SERVICE BULLETIN

HORIZONTAL STABILISER TRIM TAB CONTROL RODS IMPROVED RANGE OF ADJUSTMENT

Figure 1 Rework of Horizontal Stabiliser Trim Tab Control Rods

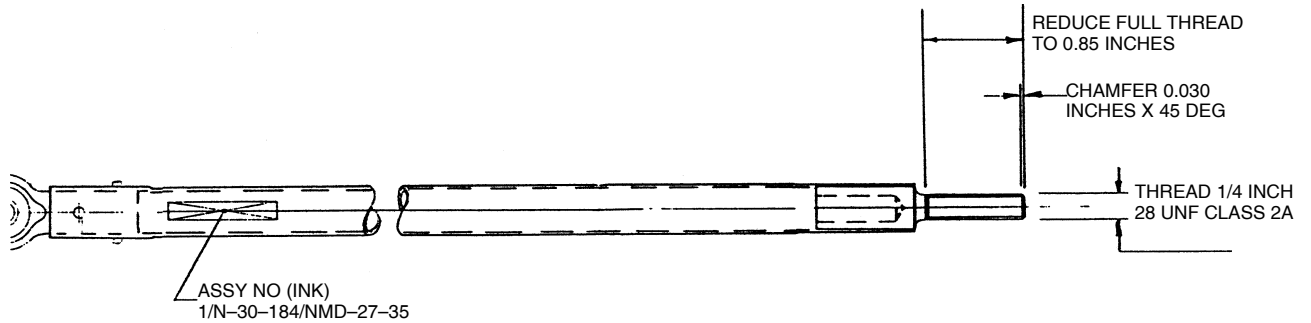
Under certain conditions of tolerance stack-up, the horizontal stabiliser trim tab control rods may not have sufficient range of adjustment to allow the Post Mod N211 rigging dimensions to be achieved.

The male threaded end of the control rod is shortened to change the range of adjustment available on the rod.

- C. Carefully rework the control rod(s) threaded end fitting (item 12) as shown on Figure 1, taking care not to damage the rod or the threads.
- D. Following the rework, inspect the rod(s) for damaged threads, damage to the tube or loose taper pins. If satisfactory, touch up the reworked end of the end-fitting with suitable primer to prevent corrosion.
